UNITED STATES PATENT AND TRADEMARK OFFICE

APPLICATION NO.	FILING DATE	FIRST NAMED INVENTOR	ATTORNEY DOCKET NO.	CONFIRMATION NO.
09/677,870	10/03/2000	Woo Hyuk Choi	2658-0240P	6124

Office Action Summary

DETAILED ACTION

FIG. 6

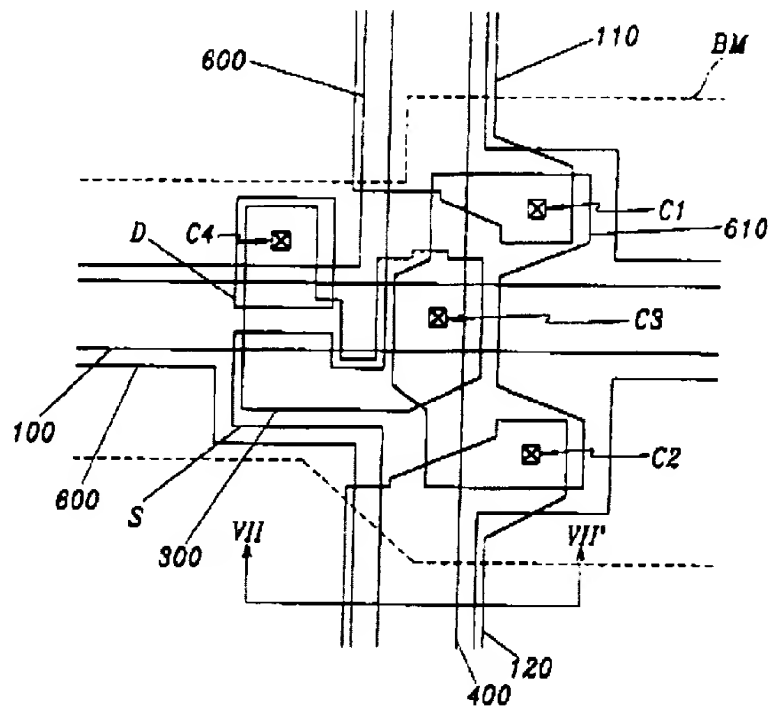
As to claims 1 and 2, Kim discloses in the third embodiment, Figures 6 and 7, (col. 6, line 35 through col. 7, line 5), a thin film transistor substrate in a liquid crystal display provided with a data lines, 400, for applying a data signals, a gate line, 100, for applying a gate signal, and a transparent pixel electrode, 600, for driving a liquid crystal cell, said substrate comprising: repair lines, 110 and 120, (Applicant's gate dummy pattern) formed of the same material layer as the gate line (col. 6, lines 38-42 and col. 2, lines 10-17) in such a manner to be extended in the vertical direction from the gate line, 100, and to overlap the pixel electrode, 600, and data line 400, to compensate for misalignment occurring along the data line.

FIG. 13

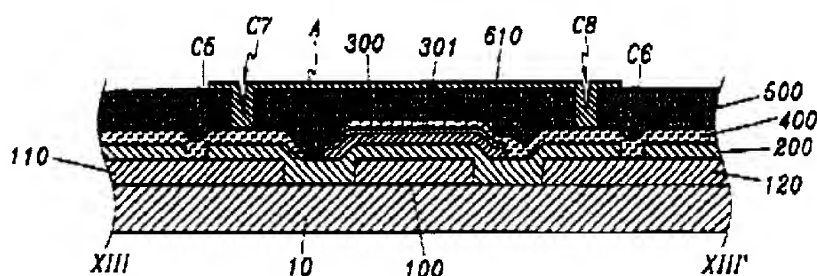
Kim teaches in Figure 13 the use of forming holes and connections to the repair lines, 110 and 120, (Applicant's gate dummy pattern) and to a connecting pattern, 610, to repair a broken data line, 400, (col. 8, lines 1-15).

FIG. 26

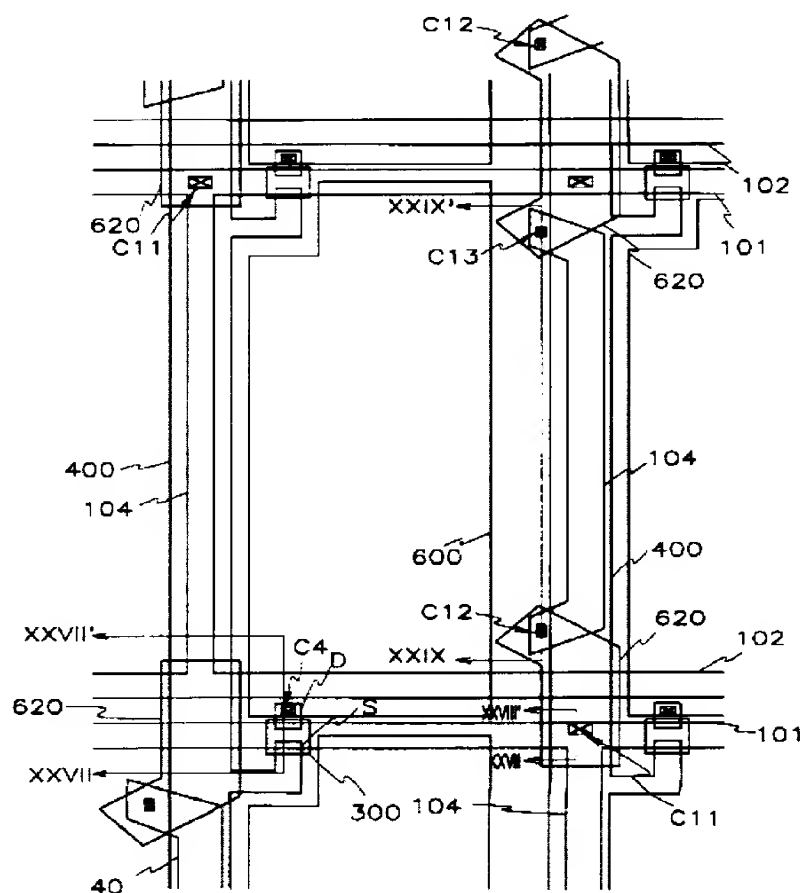
Kim teaches in Figure 26 the use of repair lines, 104, (Applicant's gate dummy pattern used as a redundancy electrode) to connect the gate line to the data line (col. 13, lines 4-17).

FIG. 19A

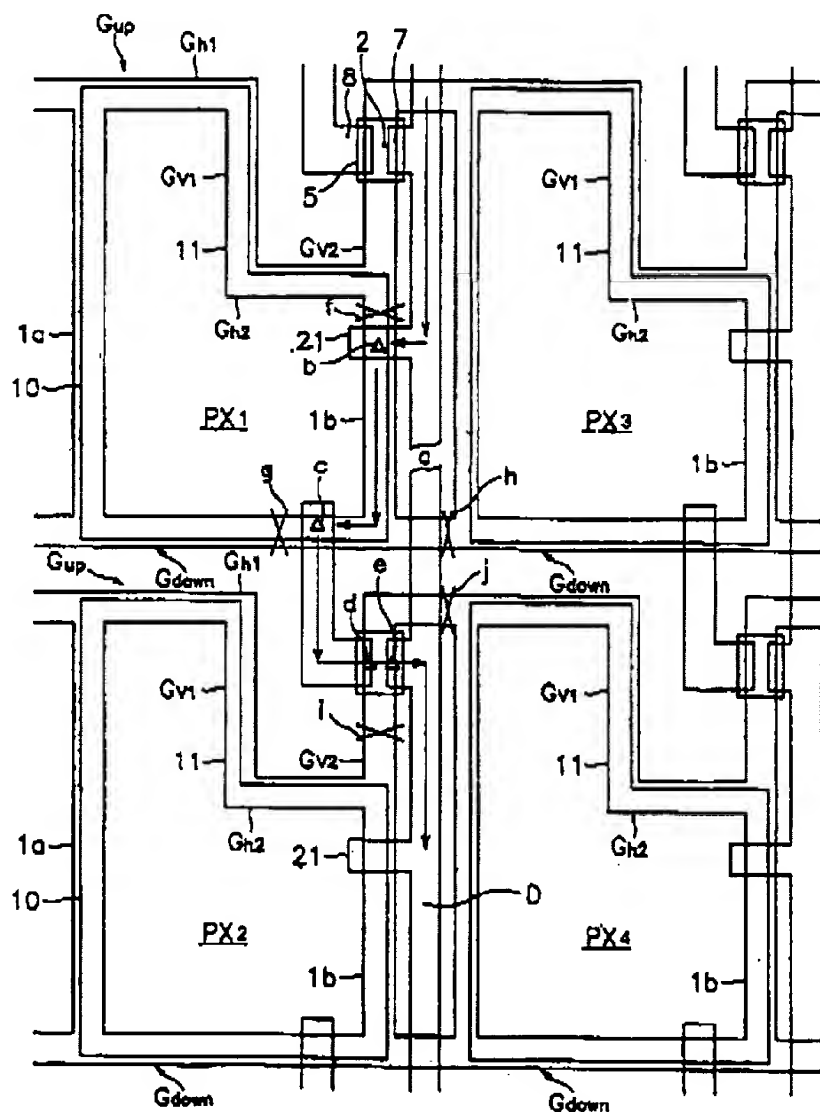
Song teaches the use of a redundant pattern in Figure 19A (G_{up} and G_{down} or 1a and 1b) as a redundancy electrode for electrically connecting the gate line to the broken data line (col. 17, lines 4-67, especially col. 17, lines 47-54) to effect repairs.

As to claim 4, Song teaches in Figures 16-27D, e.g., Figure 19A, (col. 12, line 51 through col. 25, line 45) and throughout much of the text, a substrate wherein the left and right auxiliary gate lines (Applicant's gate dummy pattern) includes a disconnect, e,

(Applicant's hole) (col. 17, lines 4-67, especially col. 17, lines 47-54) connected to the gate line and formed to permit a repair.

FIG. 18

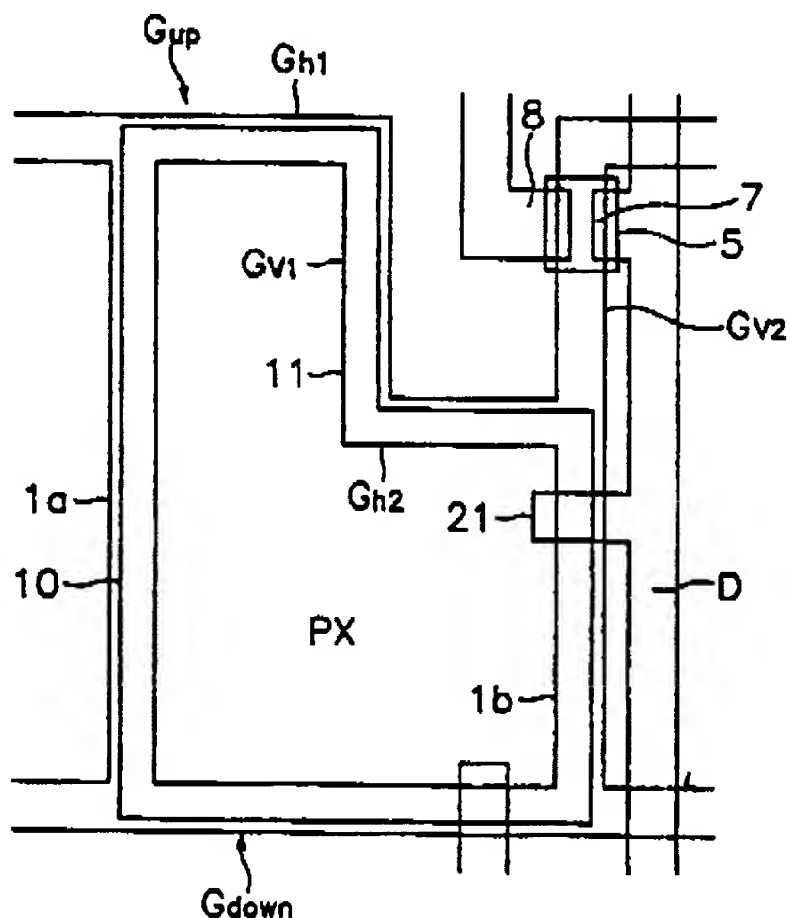
As to claim 6, Song teaches in Figure 18 a thin film transistor substrate further comprising: a storage capacitor defined by a horizontal overlapping part, G_{h2} , between the gate line and the pixel electrode, PX. Song also teaches in Figure 18 an analogous overlapping portion, 21, of the data line, D, to permit a repair.

As to claim 7, Song teaches in Figures 18 and 19A a protrusion, 21, formed in such a manner to overlap with the hole (to be created during repair), the structure of which would thereby shut off a light leaked between the gate dummy pattern and the gate line (col. 15, lines 42-63).
